APPEAL SUMMARY

Appeal ID: 23486	Project Address: 8307 N Ivanhoe St
Hearing Date: 2/26/20	Appellant Name: Ben Carr
Case No.: B-001	Appellant Phone: 9173997101
Appeal Type: Building	Plans Examiner/Inspector: Steven Mortensen
Project Type: commercial	Stories: 3 Occupancy: R-2 Construction Type: V-B
Building/Business Name: Charleston Row	Fire Sprinklers: Yes - Type 13 Throughout
Appeal Involves: Erection of a new structure	LUR or Permit Application No.: 19-262198-CO
Plan Submitted Option: pdf [File 1]	Proposed use: Multi-family Residential

Appeal item 1

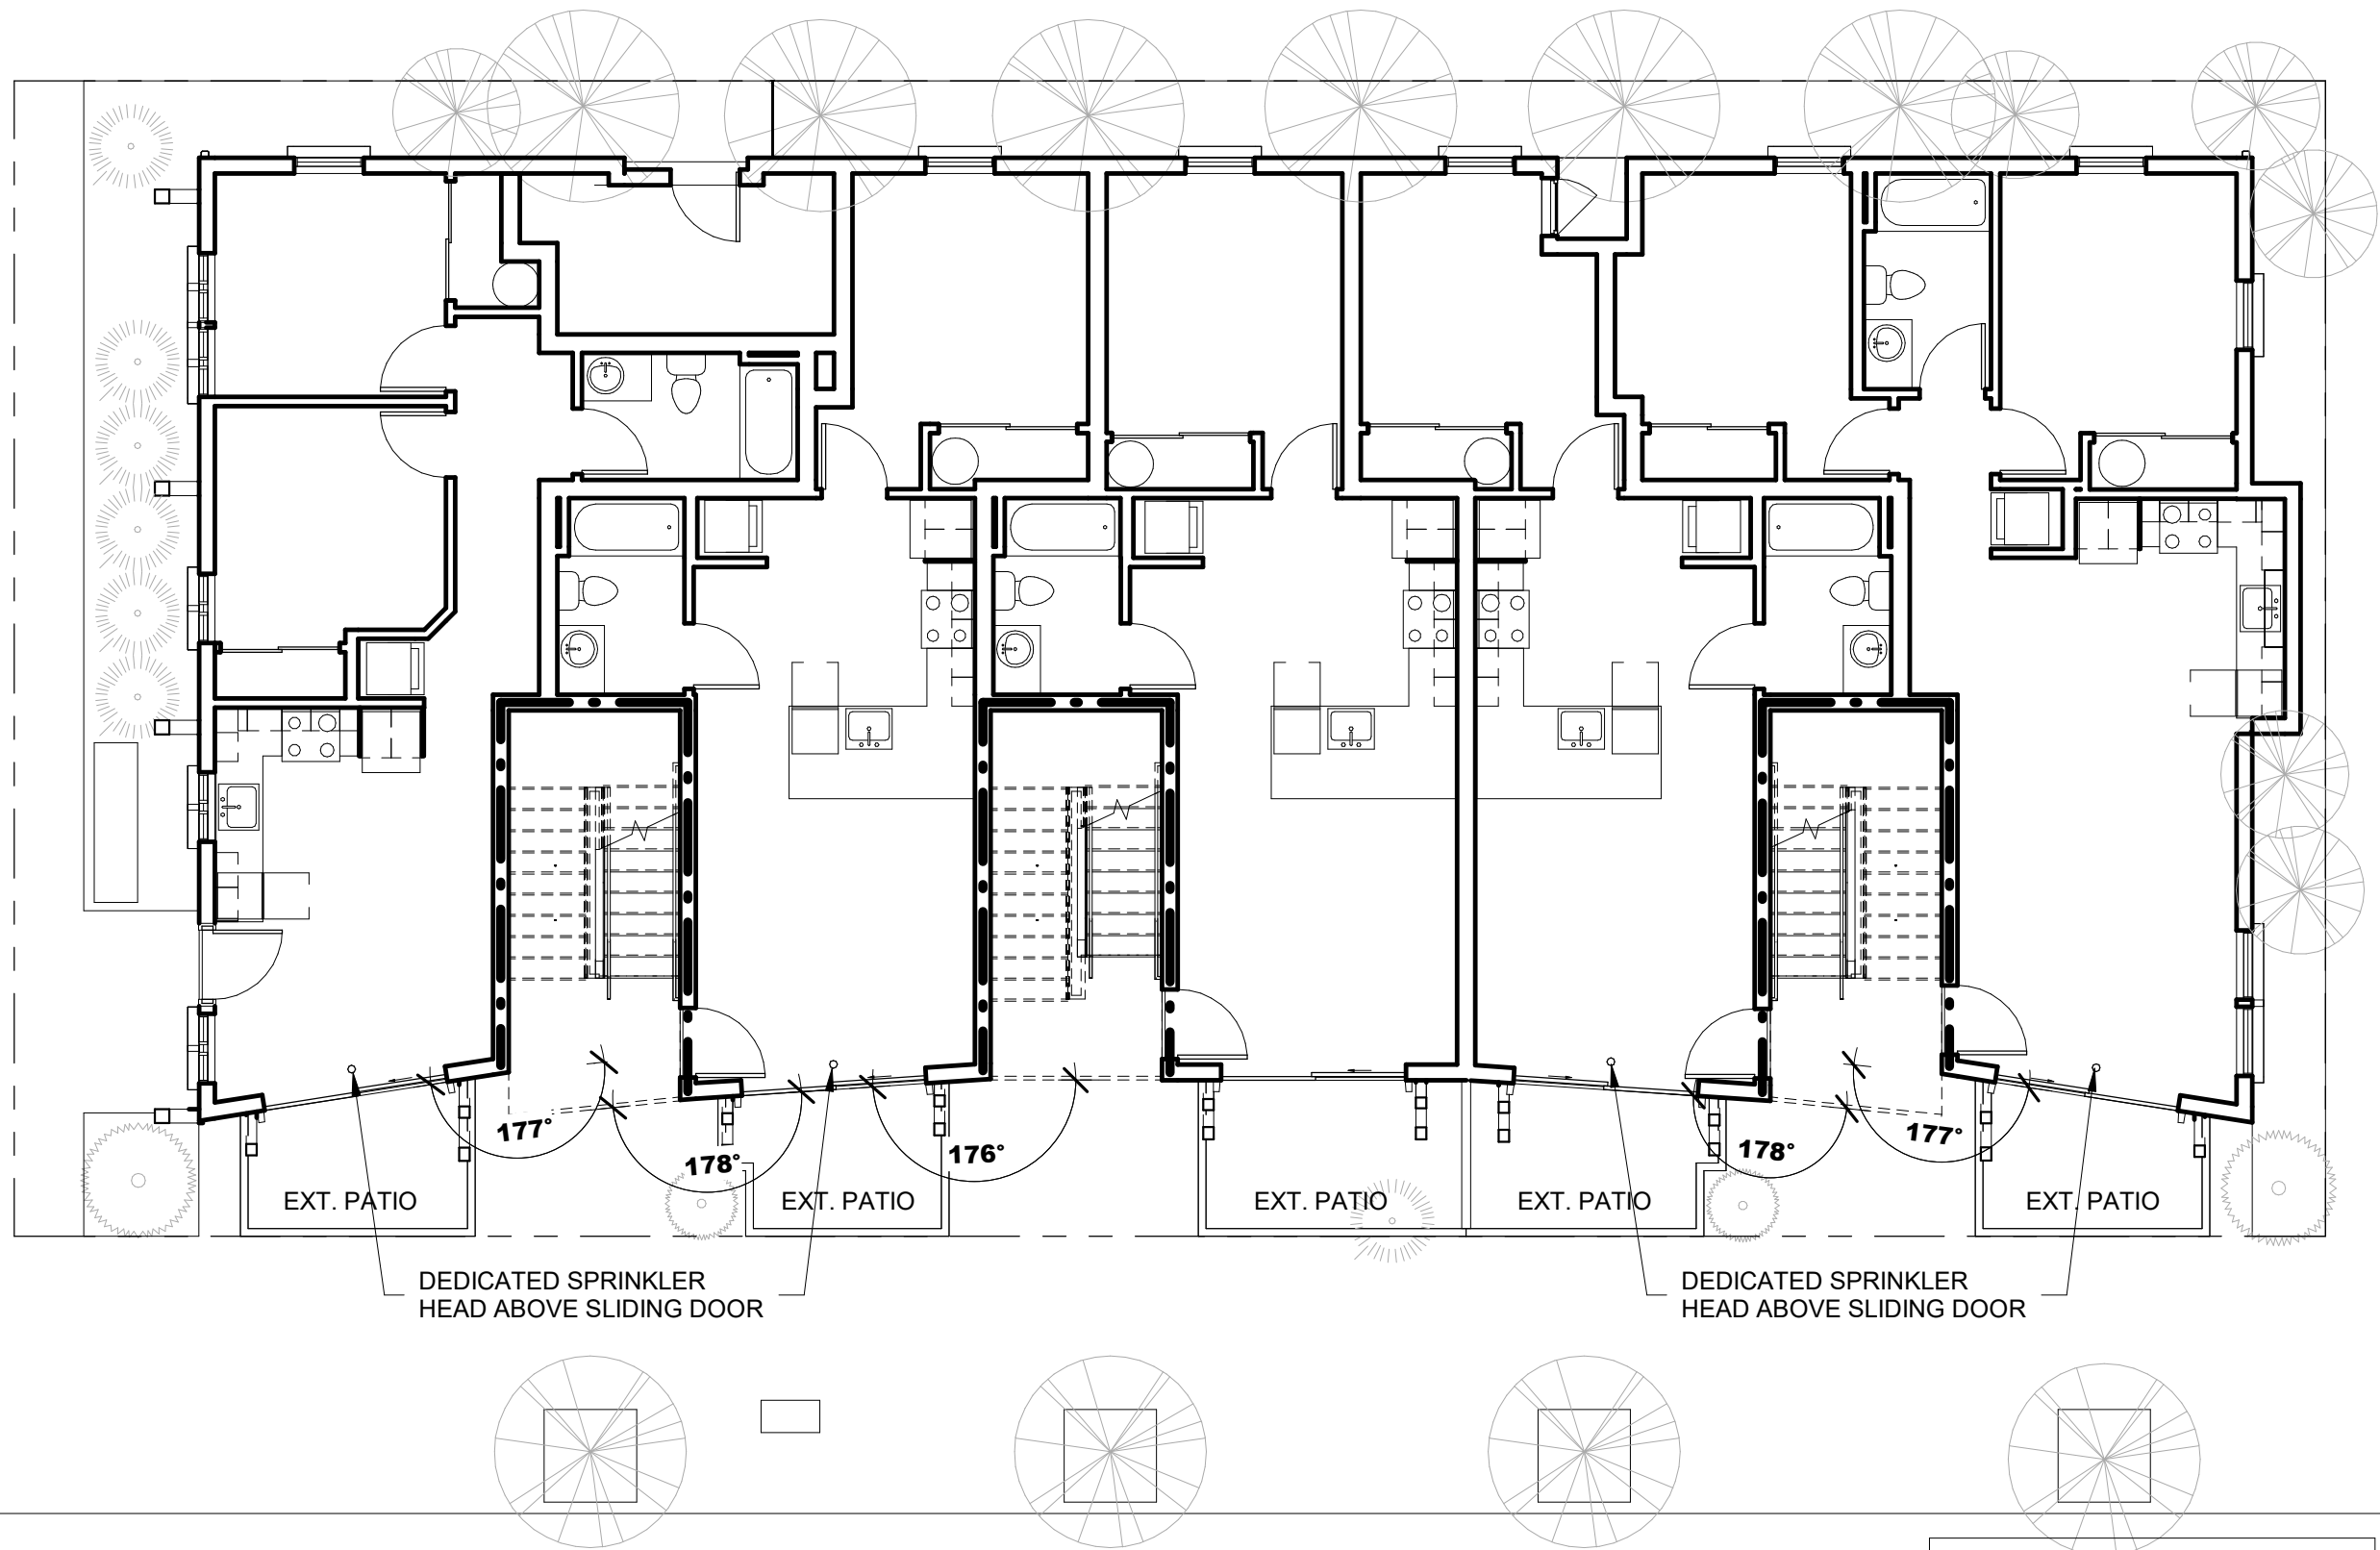
Code Modification or Alternate Requested Provide dedicated sprinkler heads at openings in walls less than 180deg adjacent to exterior exit stair landing.

On the South elevation of Charleston Row are (3) exterior exit stairways that serve units on all levels. These exterior exit stairways are utilized for egress, surrounded by 1-hour rated fire barriers on 3 sides. At the Southern end of each exterior exit stair is an open street-facing landing. Due to the faceted design of the South elevation, the angle between the stair landings and adjacent South exterior walls is slightly less than 180 degrees in some cases, identified in attached plans. Sliding glass doors are within the Southern exterior wall leading to the balcony spaces, neither of which are used for egress. On the third level, fixed transom windows are above the sliding glass doors.

At the most extreme, the ground level angle between the rated exterior exit stair wall and adjacent exterior wall is 176deg at exterior exit stair A and C, and 176deg at exterior exit stair B; levels 2 & 3 landing angle between the rated exterior exit stair wall and adjacent exterior wall is 177deg at

exterior exit stairs A and C, and 176deg at exterior exit stair B. At each of these points where the exterior wall is less than 180deg, a dedicated sprinkler head on the interior side of the sliding glass doors is proposed. Each opening will have (1) sprinkler head installed, centered on the window in the East-West direction, a maximum of 12" from the wall in the North-South direction, and a maximum of 12" below the ceiling. The sprinkler head will be capable of wetting the entire surface of the window.

Reason for alternative Providing dedicated sprinkler heads at the unprotected openings which are within 180deg of the exterior exit stair landing will serve the goal of protecting the openings from the exterior exit stair and vice versa. In this case, the additional sprinkler heads provide an equivalent level of life safety as a ¾ hour protected opening.

Type 13 water curtain sprinkler protection at non-fire rated openings in exterior walls within 180 degrees of exit stair: Granted provided transom windows are non-operable and sprinklers are spaced not more than 6 feet apart and placed a minimum of 6 inches and a maximum of 12 inches from the opening(s) and a maximum of 12 inches below the ceiling. Sprinklers are to be installed on the occupied side of the openings. A separate permit from the Fire Marshal’s Office is required.
Note: Sliding glass doors require additional sprinkler protection as proposed and noted above but are not required to be self closing.
Appellant may contact John Butler (503 823-7339) with questions.
